September 7, 2000
IPN-00-064

SUBJECT: Indian Point 3 Nuclear Power Plant
Docket No. 50-286
License No. DPR-64
**Proposed Technical Specification Amendment to Extend the
Surveillance Frequency for the Fuel Storage Building Emergency
Ventilation System**

ATTACHMENT I TO IPN-00-064

Safety Evaluation for Proposed Technical Specification Amendment to Extend the
Surveillance Frequency for the Fuel Storage Building Emergency Ventilation System

FSBEV Charcoal % Efficiency

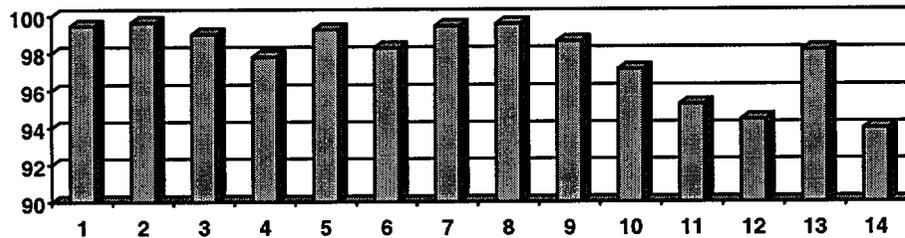
Technical Specification section 4.5.A.6.c requires surveillance on the FSBEV system at a frequency of 720 hours to determine methyl iodine removal efficiency of the charcoal and leak tightness and visual inspection of the charcoal and High Efficiency Particulate Adsorbers (HEPA). For twelve (12) years of charcoal service life in the FSBEV system, the below table shows the performance of the charcoal filters:

During the twelve years of service life, the charcoal met the Technical Specification requirement for efficiency with margin to the requirement of $\geq 90\%$. Between January 1997 through July 1999, the charcoal filter experienced approximately 4300 hours of service with a sufficiently predictable trend. Based on these 4300 hours of operation with filter performance maintained above the required 90% criteria, it is reasonable to expect satisfactory filter performance with an extended surveillance frequency of 1440 hours. In August 1999, the charcoal was replaced and tested to an efficiency of $>98.9\%$ in accordance with ASTM D-3803-1989 and at a face velocity of 50 ft/min. With the adoption of the testing standard ASTM D-3803-1989, there is a higher confidence that the safety factor of at least 2 will be ensured with charcoal surveillance results of $\geq 90\%$. The IP3 Safety Analysis Report assumes no credit for FSBEV charcoal filtration but presents that if credit were taken for charcoal filtration at a 90% elemental iodine and a 70% organic iodine removal rate, then the dose to the thyroid for site boundary would be a value well within 10CFR100. Comparing the 70% organic iodine removal rate used in the analysis to the $\geq 90\%$ methyl iodine removal rate as tested would represent a safety factor of 3 which is more conservative than the required safety factor of 2.
